Concept Plan Changes

Regulating Plan Changes

Changes from March 12, 2020 draft

Figure 4.1

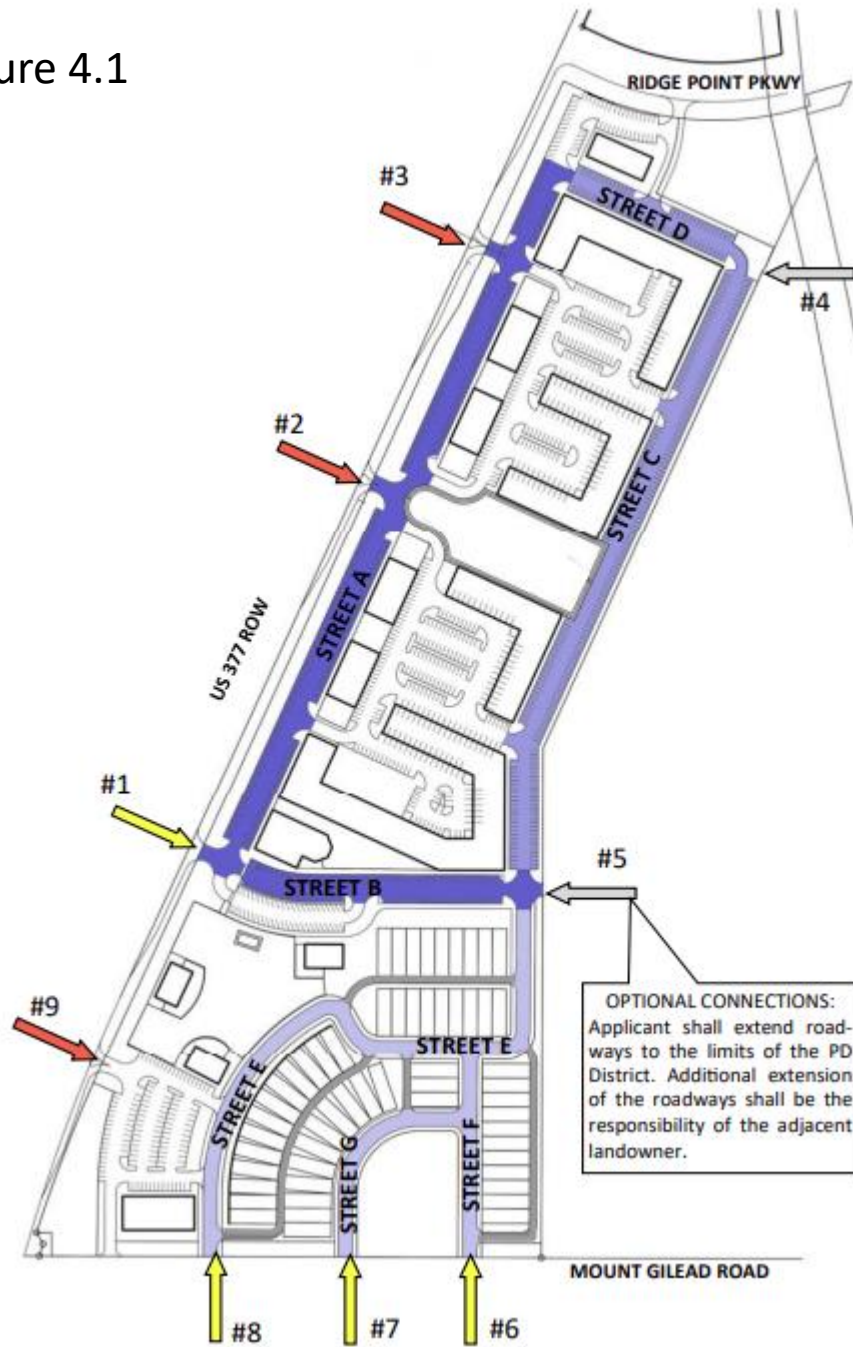
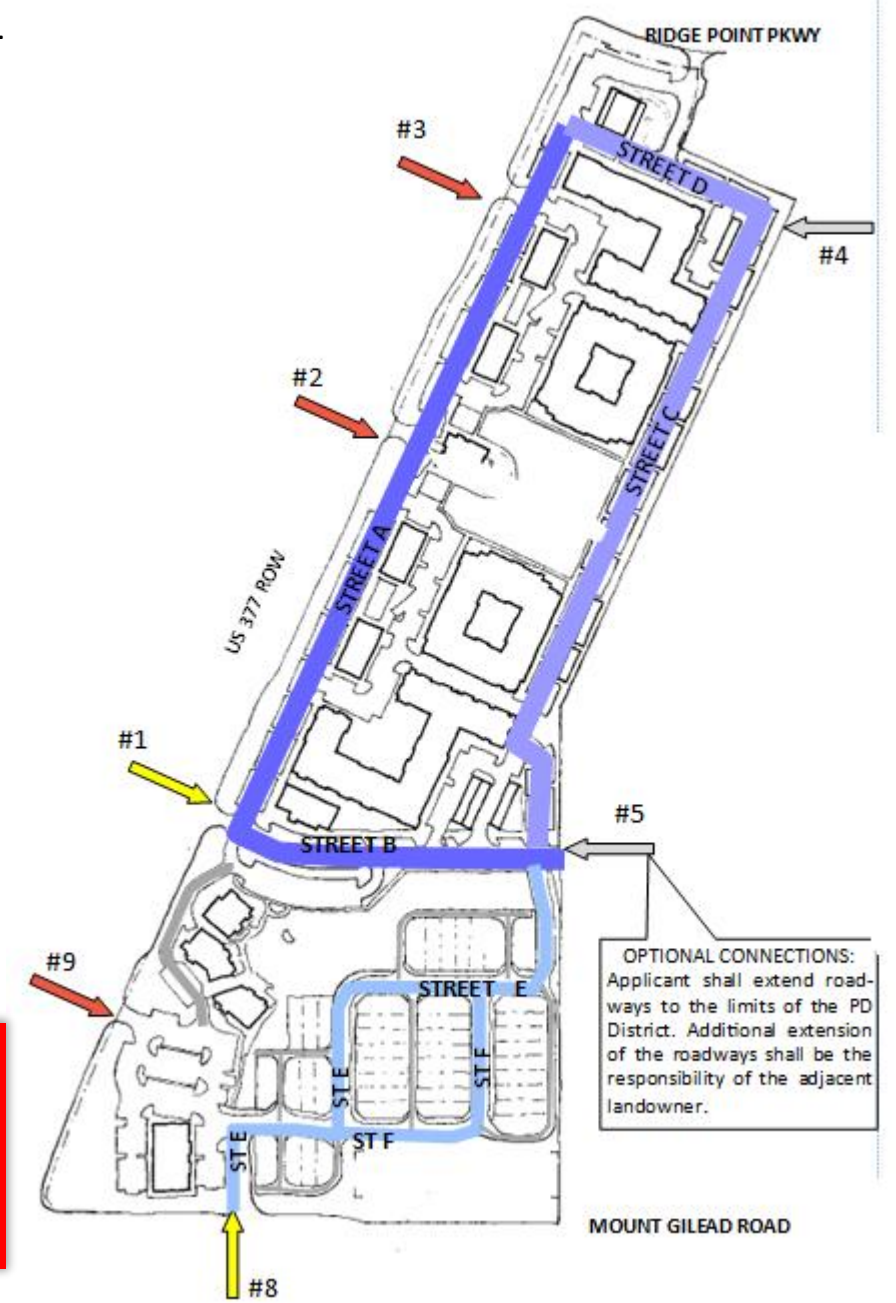
Removed Streets G and F, given new single family home configuration and plan consistent with concept plan on Pg 11".

(P16): Updated Note 4 to remove reference to Streets F&G, updated Figure 4.1

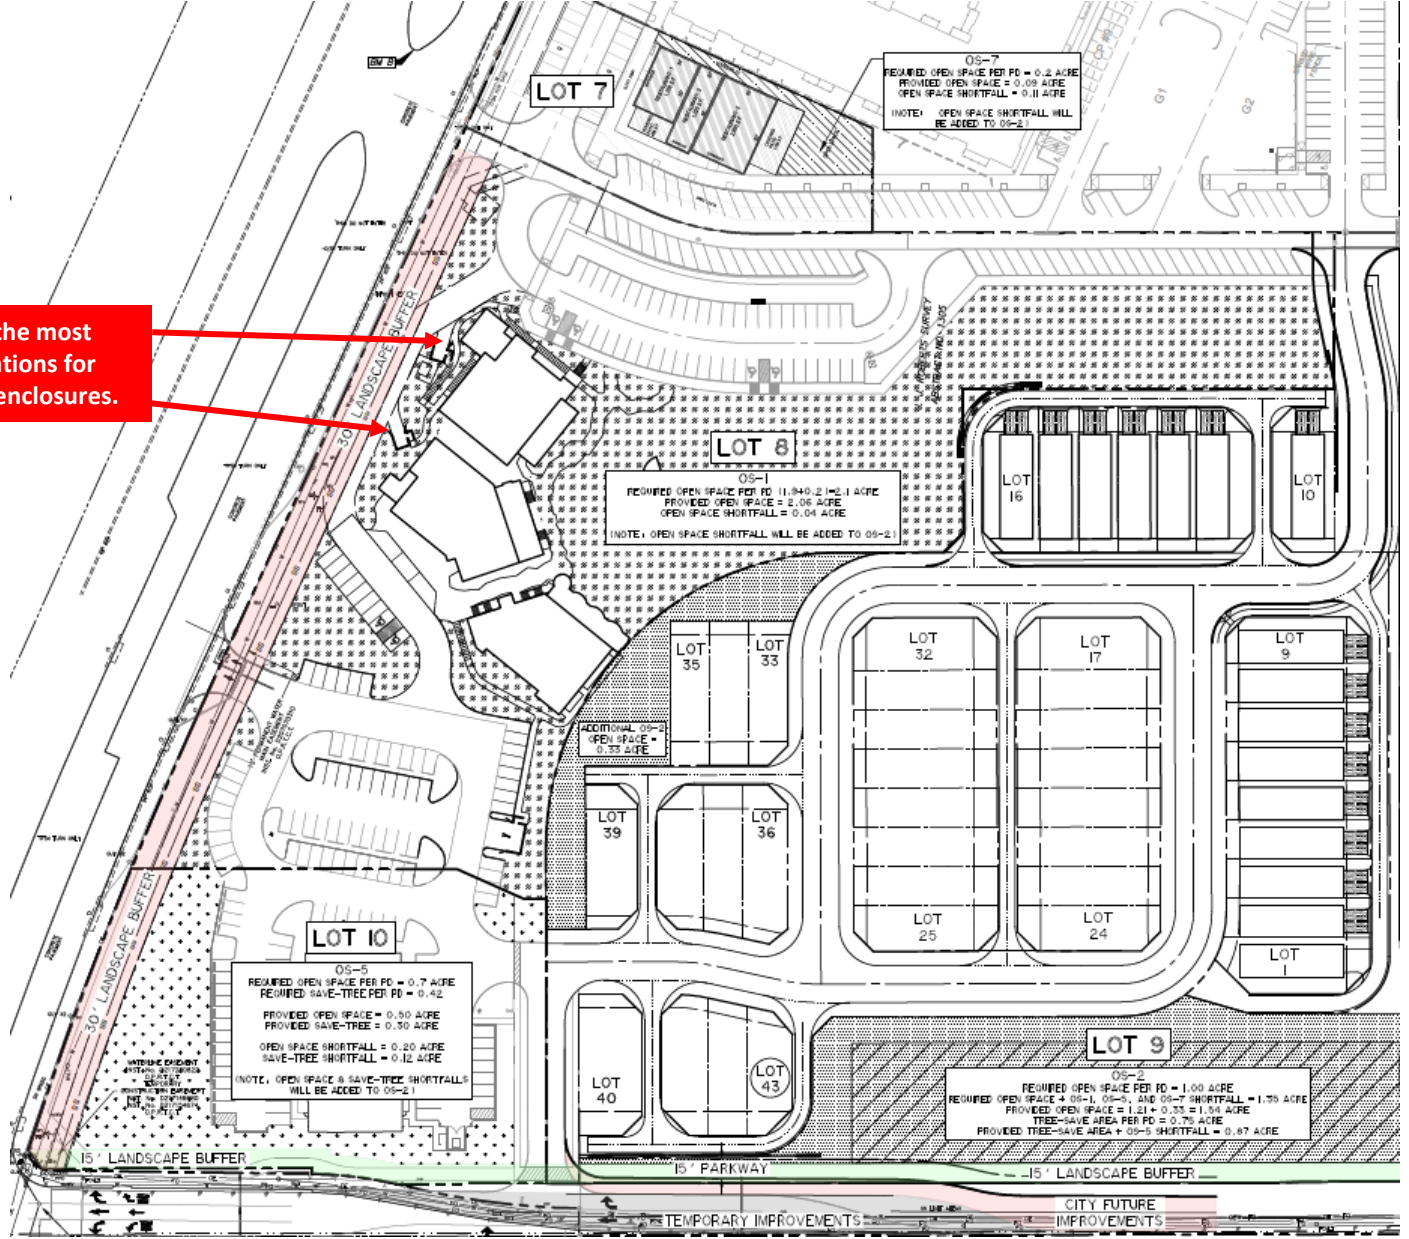
Updated Table 4.1 to remove streets F & G, added note permitting dumpster enclosure along 377 in Block A2 so long as it is screened by landscaping, meets pedestrian access and materials requirements and meets trash vendor's access requirements

These are the most logical locations for dumpster enclosures.

*A dumpster enclosure may be installed along 377 in Block A2 so long as it is screened by landscaping, meets pedestrian access and materials requirements and meets trash vendor's access requirements.

**FIGURE 5.1
OPEN SPACE PLAN**

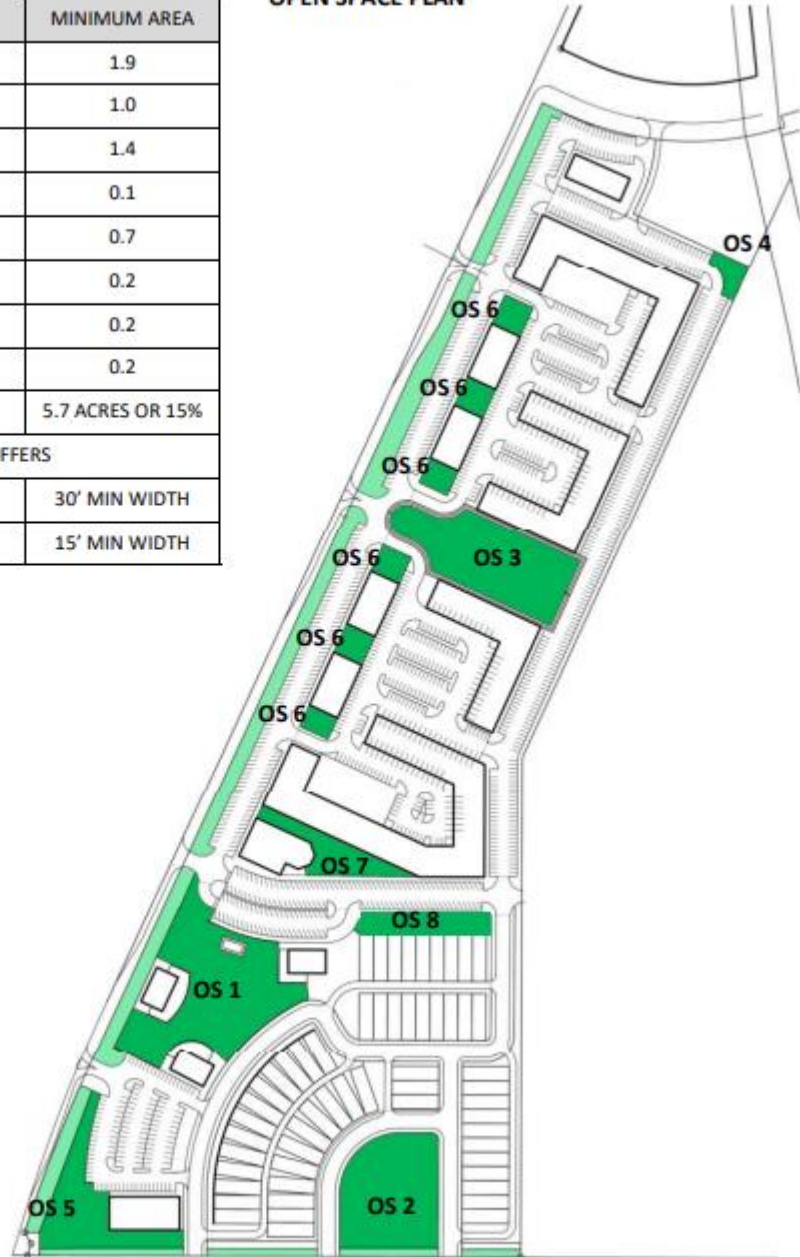
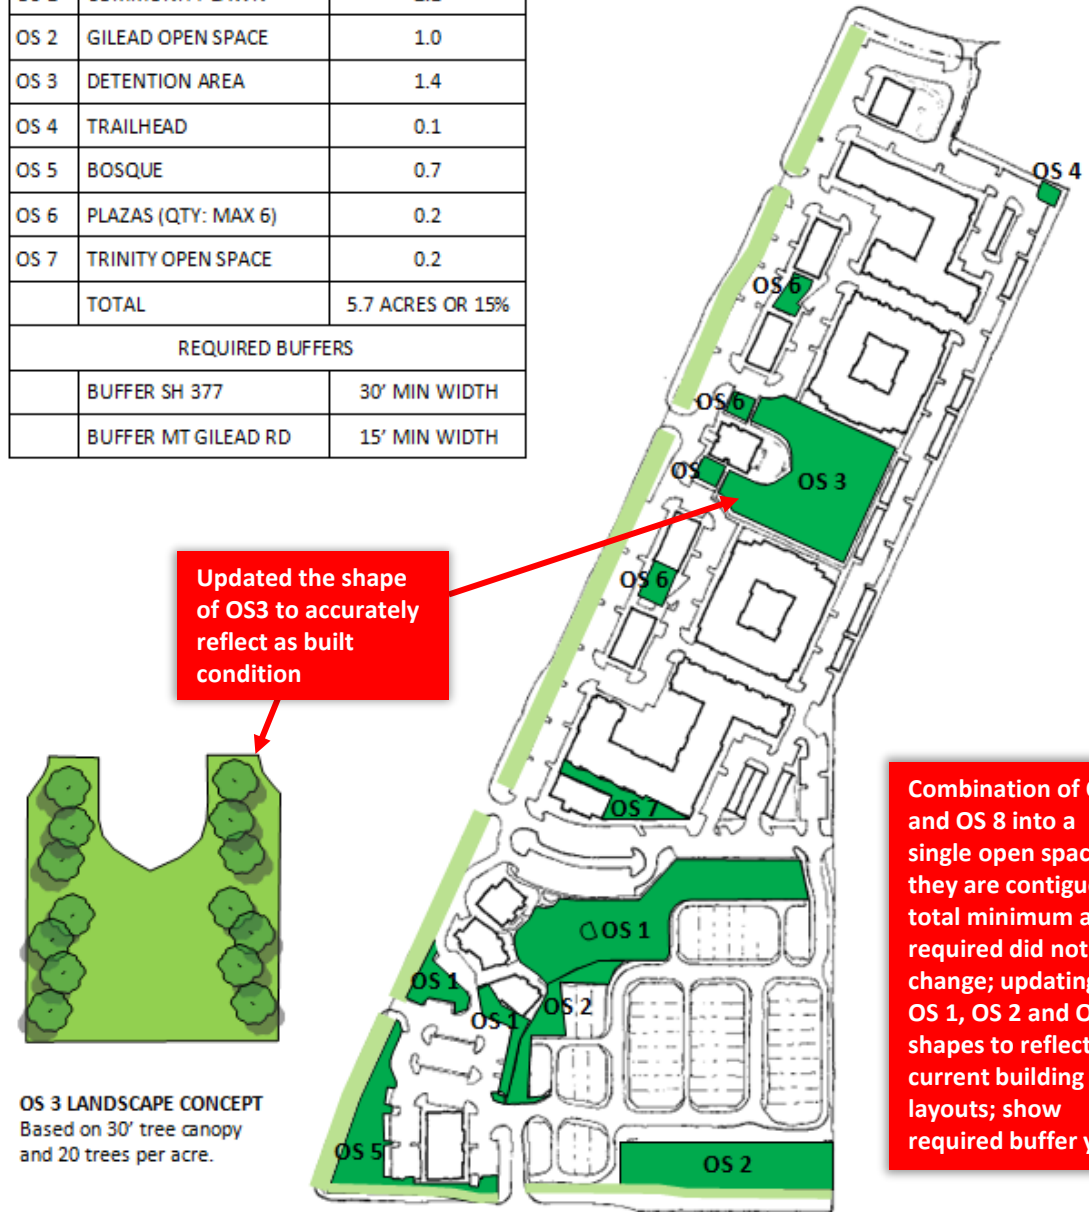
Combination of OS1 and OS 8 into a single open space as they are contiguous; total minimum area required did not change; updating of OS 1, OS 2 and OS 5 shapes to reflect current building layouts; show required buffer yard.

(P22): updated figure 5.1 and table 5.1 to remove Linear Park OS 8 and incorporate its 0.2 acre minimum into OS 1, illustrate OS 3's current configuration (its as-built condition exceeds the minimum 1.4 acre open space) and show the required buffer yard along 377 (30') and Mt Gilead (15')

FIGURE 5.3
PEDESTRIAN NETWORK

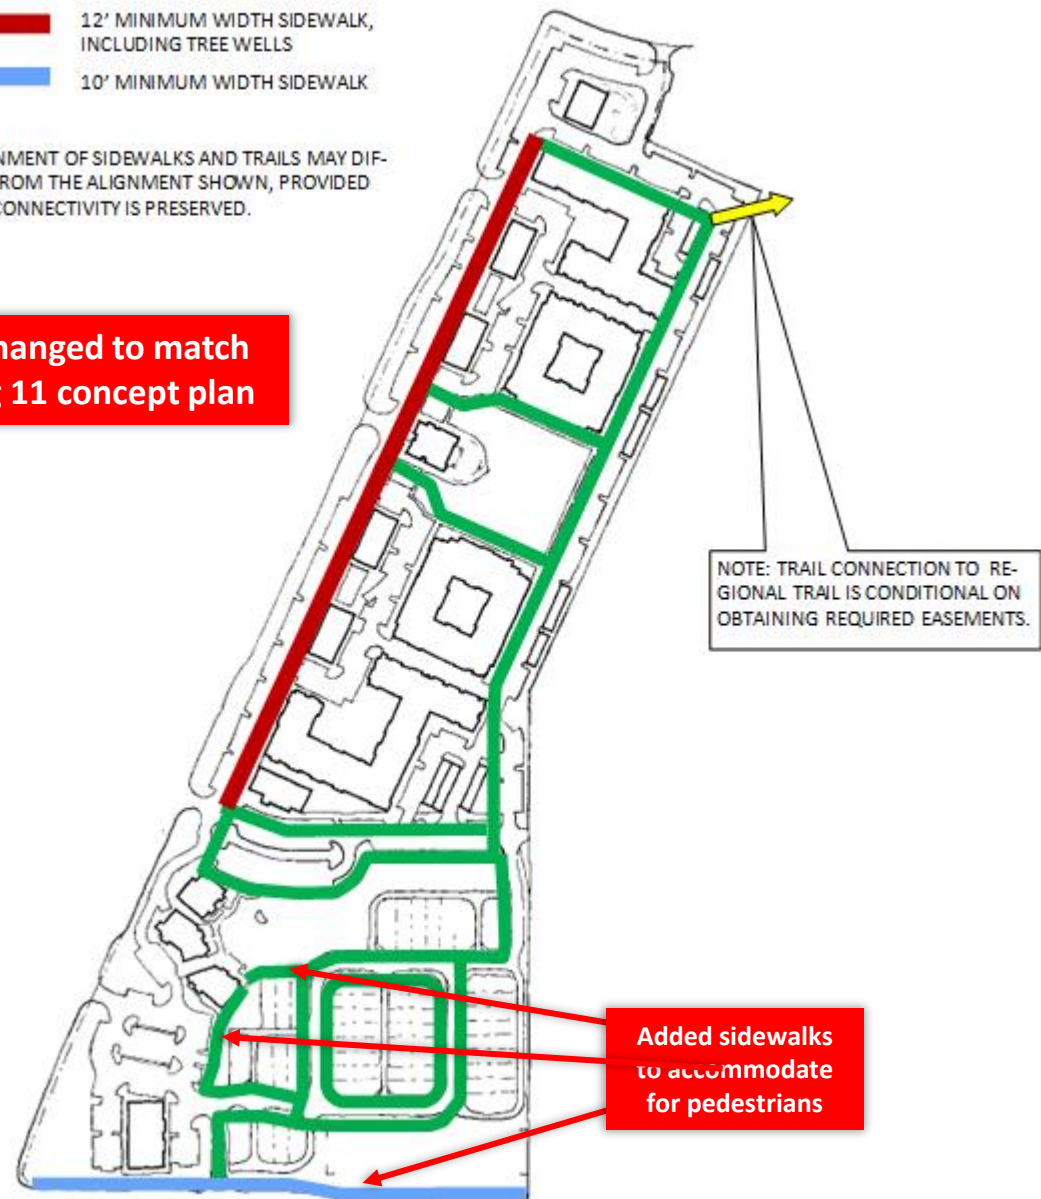
Changed to match Pg 11 concept plan

(P25): updated figure 5.3

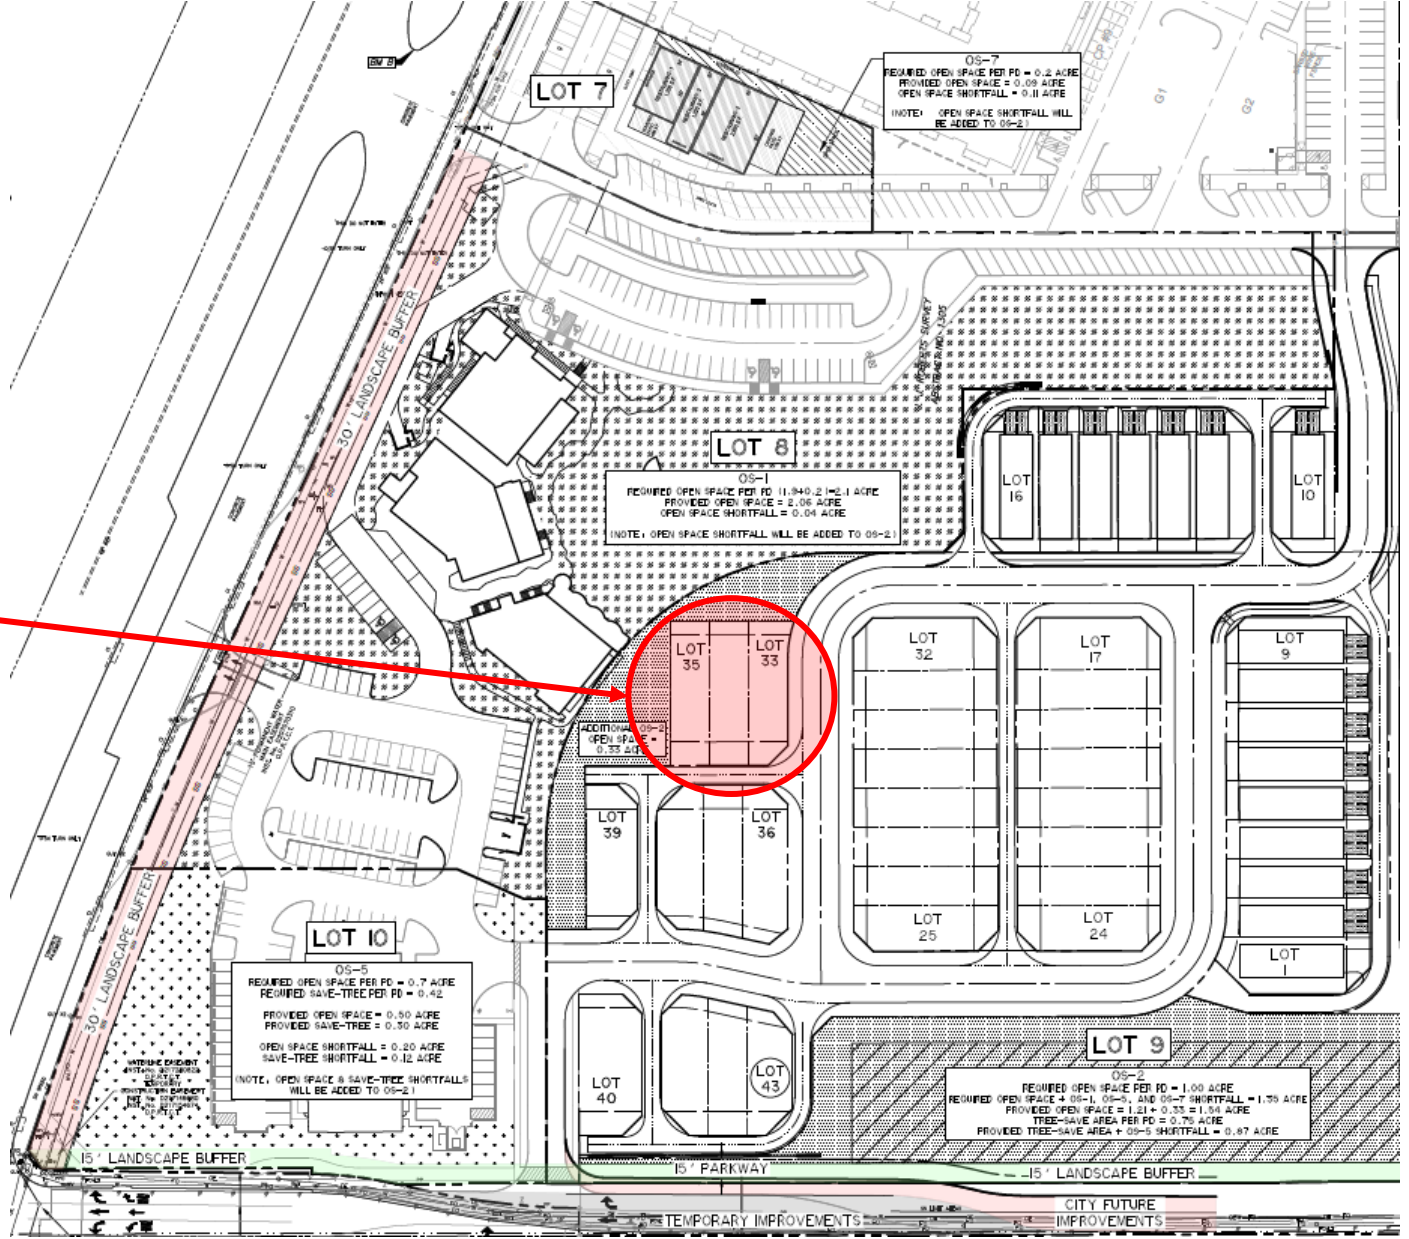
These 3 home lots do not front to a street; therefore, we propose their front doors face the community lawn amenity. Lots cannot be rotated due to alley and open space needs, so front doors must face lawn amenity. We believe this will be desirable to buyers.

(P30): Added language to allow front doors on not more than ten percent (10%) of single-family home lots to face Center Stage/Community Lawn amenity in the absence of a public street directly adjacent to front façade of the homes

FIGURE 7.2
GROUND FLOOR DESIGN TYPES FOR
BLOCKS B AND C

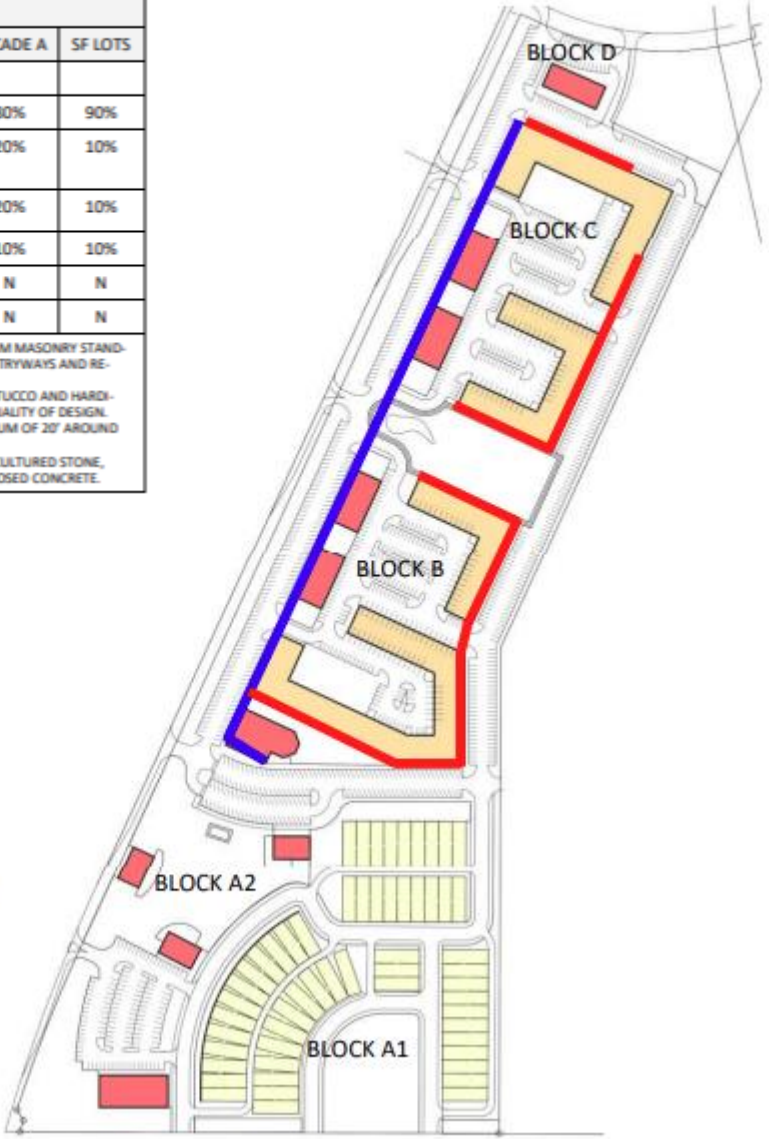
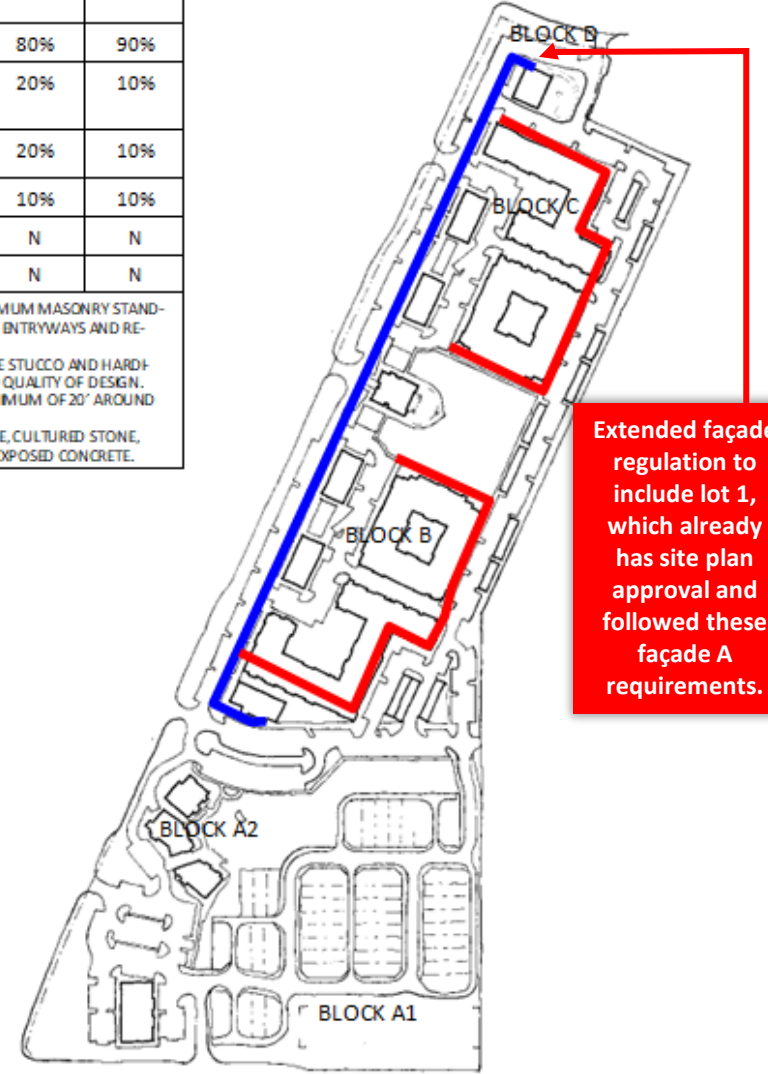
Removed the word "front" to include side facing facades.

Extended façade regulation to include lot 1, which already has site plan approval and followed these façade A requirements.

(P32): updated figure 7.2. Removed the word "front" to include side facing facades.
